# 7280 NEVADA LANE

### GRADING AND EROSION CONTROL PLANS

PCD FILING NO. : PPR-2411

**LEVEL SPREADER SECTION C-C**  
SCALE: N.T.S.

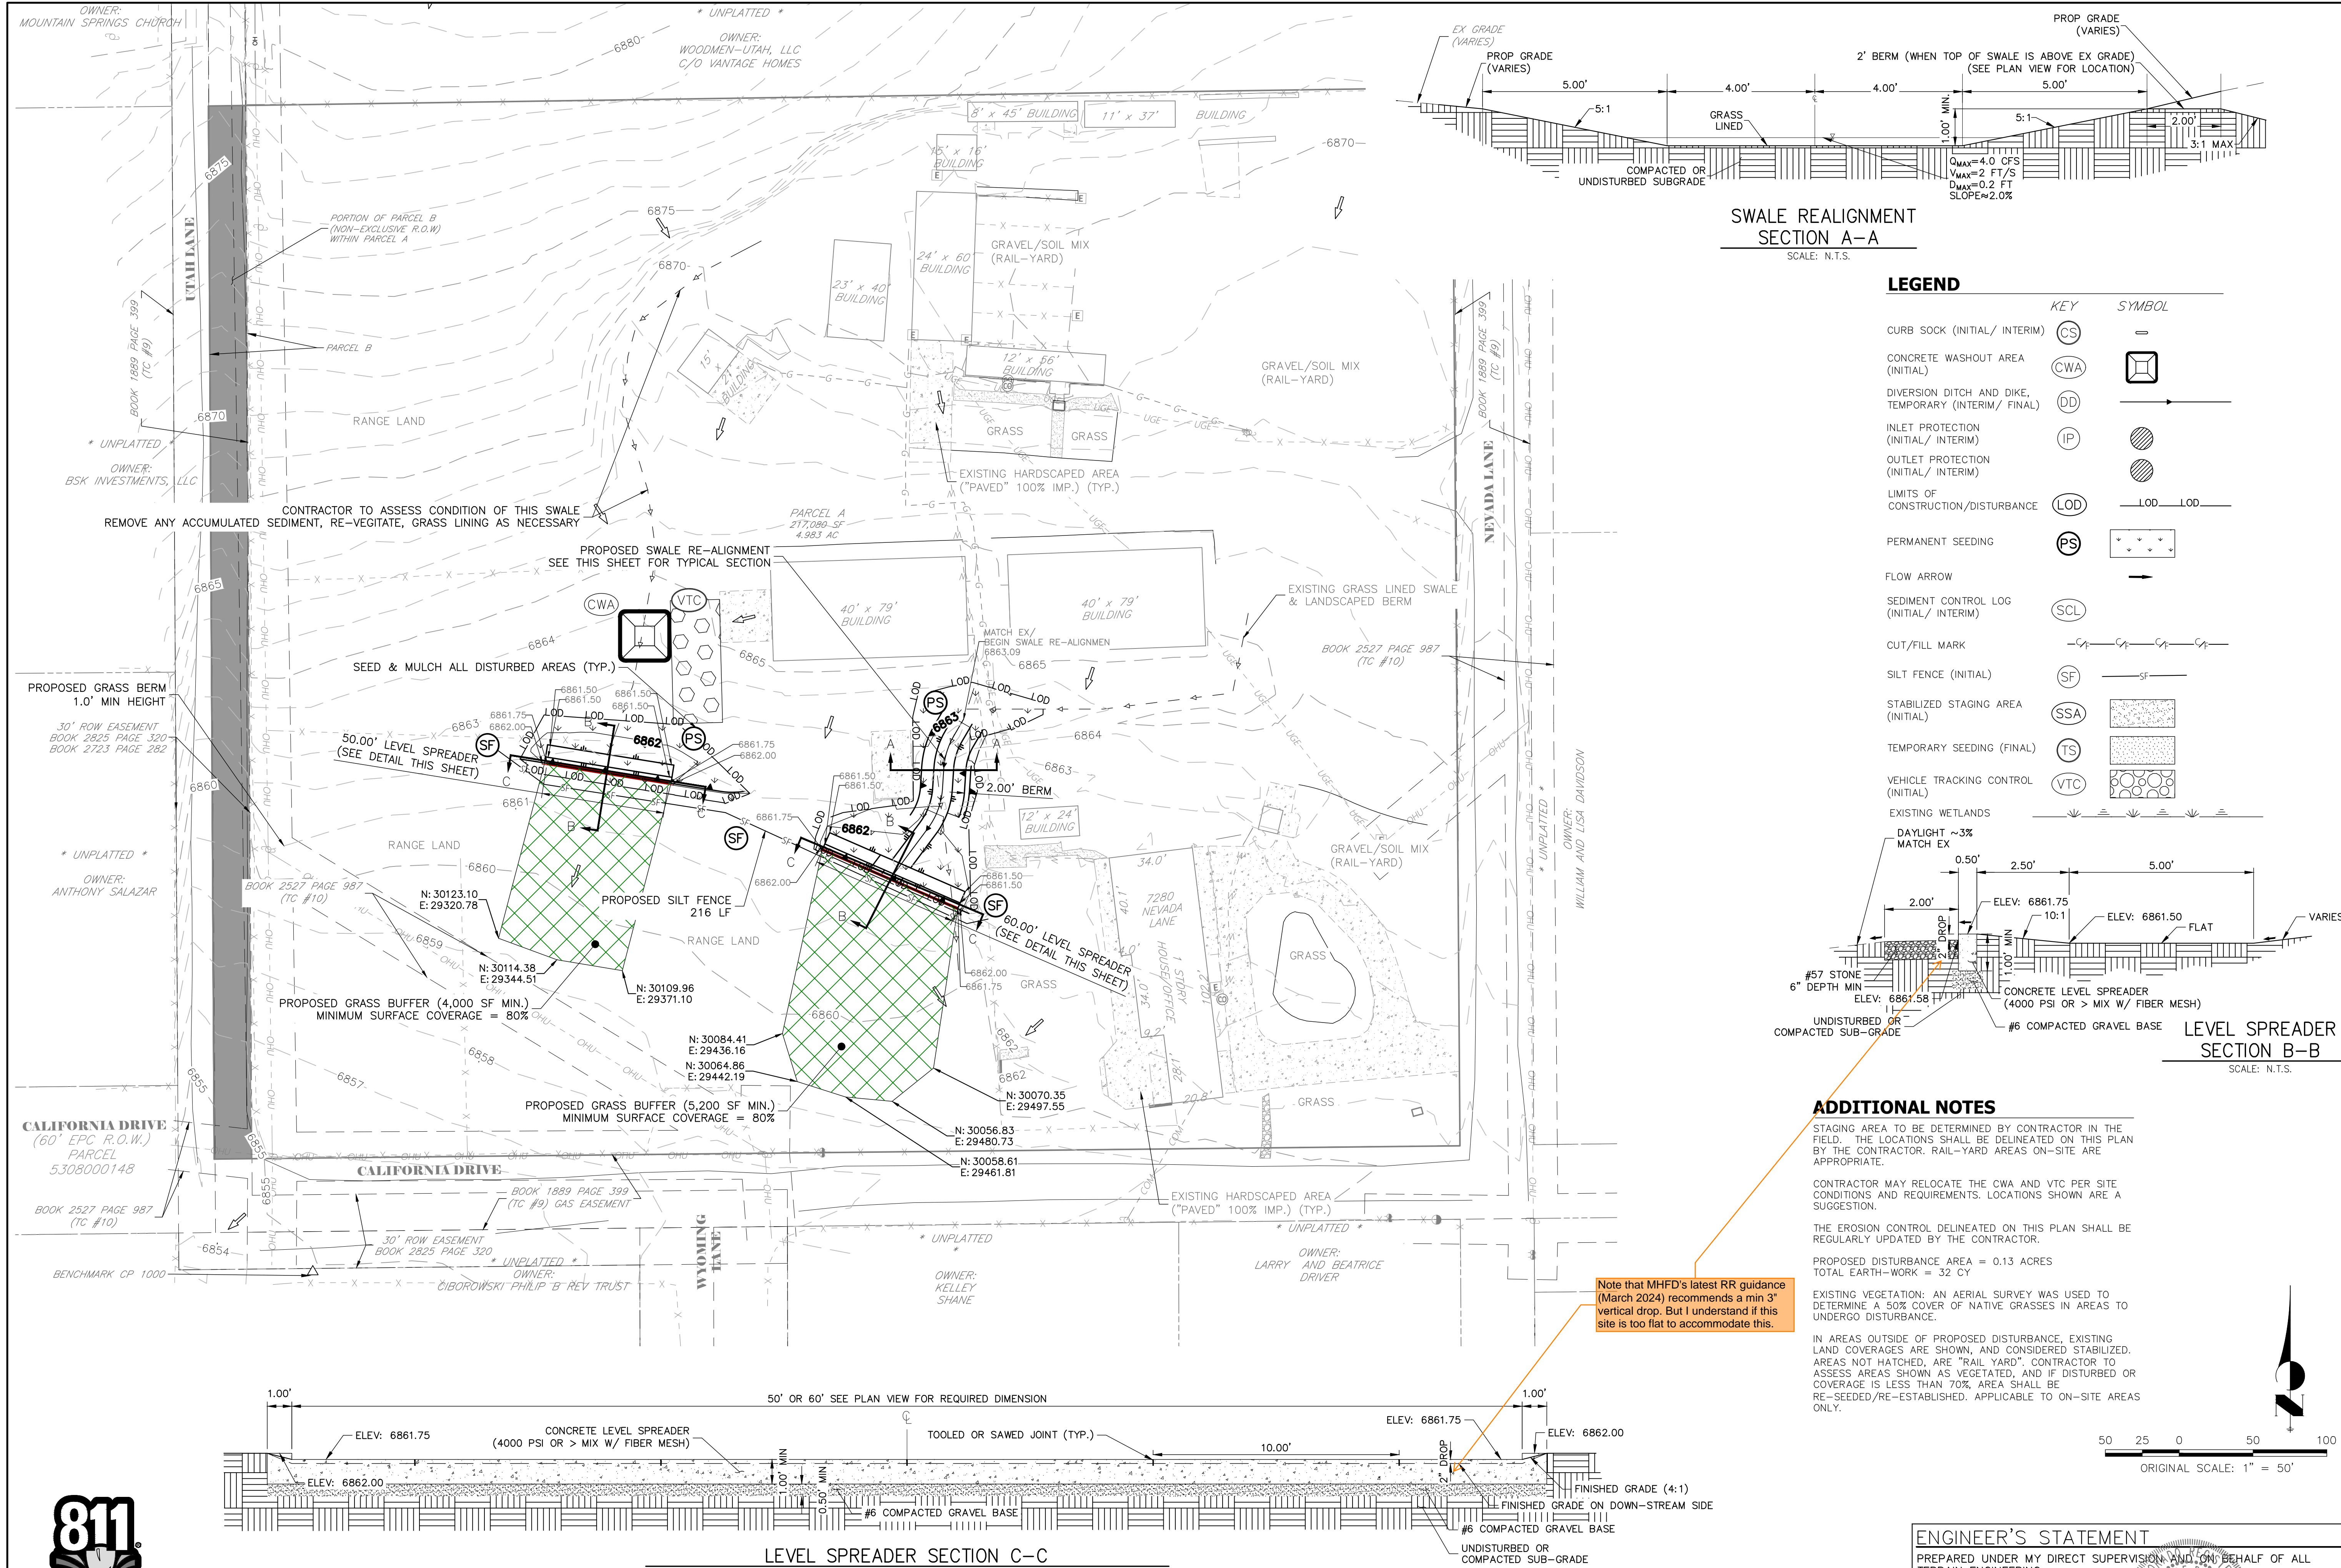
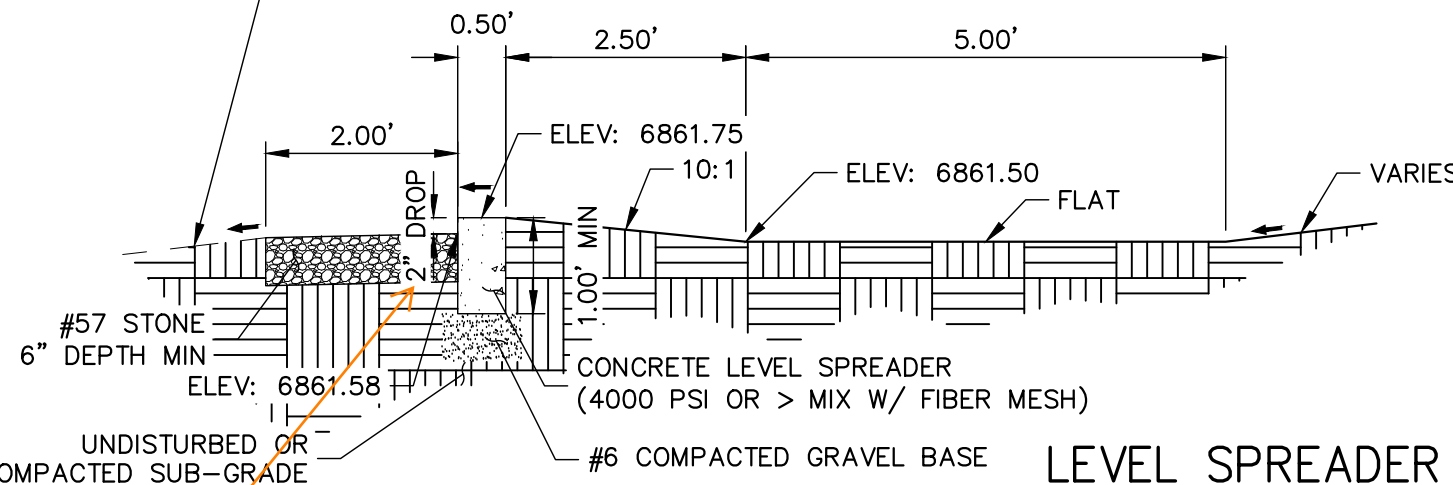
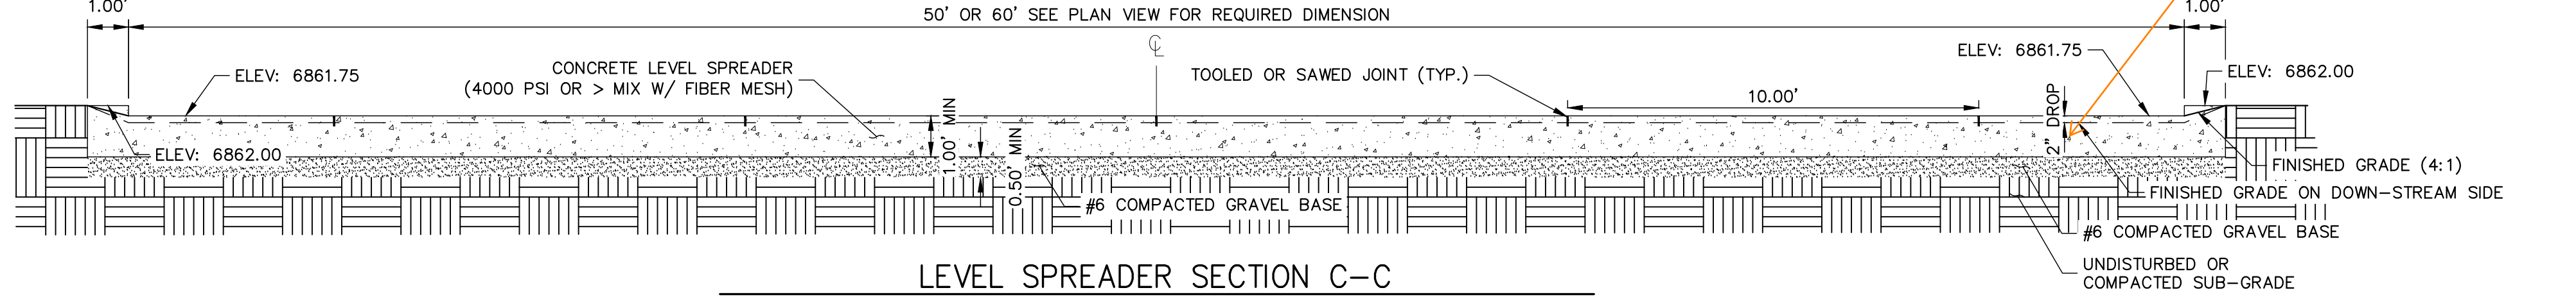
Note that MHFD's latest RR guidance (March 2024) recommends a min 3" vertical drop. But I understand if this site is too flat to accommodate this.
